**0014** Technical Service Information**Subject:** Cylinder head gaskets**Relates to:** 61-37250-00 / -10**Make:** Opel**Model(s):** Agila, Corsa**Engine code:** Z 10 XEP**Repair thickness CHG 1.0 Opel
Twinport / Z 10 XEP**

Figure_Cylinder head gasket, Reinz no. 61-37250

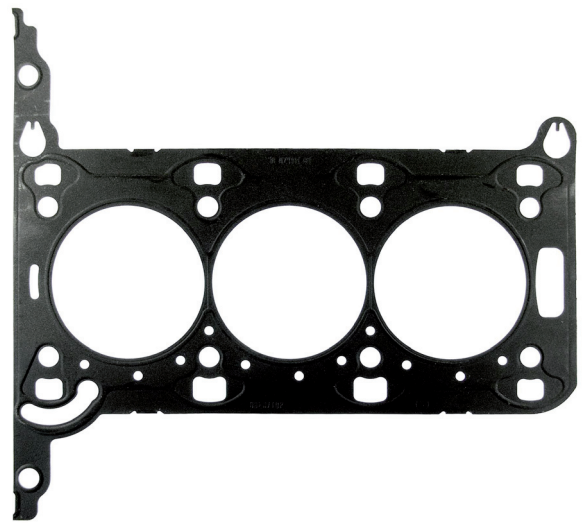
With the new exclusive repair thickness for the Cylinder Head Gasket 61-37250-00 = Opel 56 07 838, Dana offers the perfect solution for reliable sealing of reworked cylinder heads and cylinder blocks.

The repair thickness is 0.25 mm thicker than the original. After necessary surface machining, this thickness thus offers best sealing results up to this measurement.

The order number for the repair thickness is **61-37250-10**.

Caution: After the cylinder head and cylinder block have been machined, the surface roughnesses must be in a tolerance band between 7 µm and 20 µm. The waviness value should not exceed 20 µm.
